Project	IEEE 802.16 Broadband Wireless Access Working Group < <a href="http://ieee802.org/16">http://ieee802.org/16</a> >	
Title	A Proposal for Construction and Transmission of MAC PDU in 802.16j	
Date Submitted	[2006-11-03]	
Source(s)	Sean Cai, Qu Hongyun ZTE Corporation	scai@zteusa.com qu.hongyun@zte.com.cn
Re:	Response to a call for technical proposal for the TG Relay.	
Abstract	A proposal for construction and transmission of MAC PDU in 802.16j is submitted in this contribution.	
Purpose	Adopt this technical proposal as part of the baseline document.	
Notice	This document has been prepared to assist IEEE 802.16. It is offered as a basis for discussion and is not binding on the contributing individual(s) or organization(s). The material in this document is subject to change in form and content after further study. The contributor(s) reserve(s) the right to add, amend or withdraw material contained herein.

# A Proposal for Construction and Transmission of MAC PDU in 802.16j

Figure 25a Downlink MAC PDU concatenation example

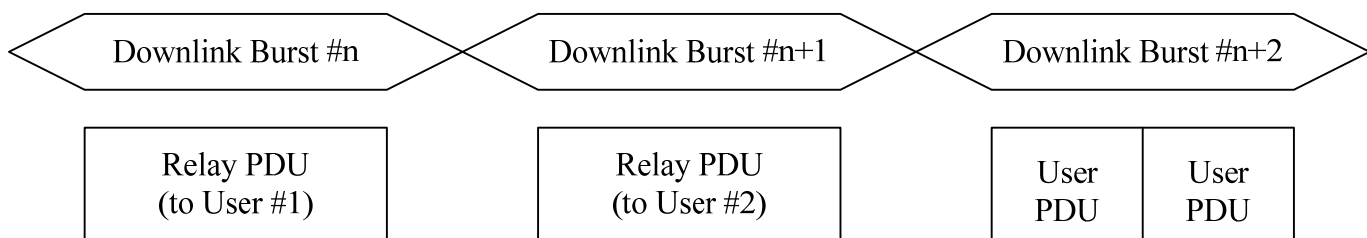
## [Add the following contents at the end of section 6.3.3.2 Concatenation]

*The MAC PDUs from the network are for the subscriber stations which communicate with BS directly or via one hop or multiple hops relay stations. These MAC PDUs should be divided into the groups based on the relay station firstly. The general PDU groups should include the MAC PDUs for the subscriber stations which communicate with BS directly. The different Relay PDU groups should be created based on relay stations. The MAC PDUs for subscriber stations which communicate with BS via same relay stations or partially same relay stations can belong to the same relay PDU group. Then the Relay PDU should be created from the corresponding Relay PDU group.*

*The general MAC PDU for subscriber station belonging to the general PDU group may be concatenated into a single transmission in either uplink or downlink directions. The relay PDU for one relay station may be concatenated into a single transmission in either uplink or downlink. The general PDU and the relay PDU for different relay station shall not be concatenated into a single transmission in uplink or downlink.*

*Figure 25a illustrates the concept for a downlink burst transmission. In Figure 25a the user #1 and the user #2 communicate with BS via different relay stations. The PDUs for them are transmitted in different downlink bursts. And the PDUs for the user direct communication with BS are transmitted in the different downlink bursts from the relay PDUs.*
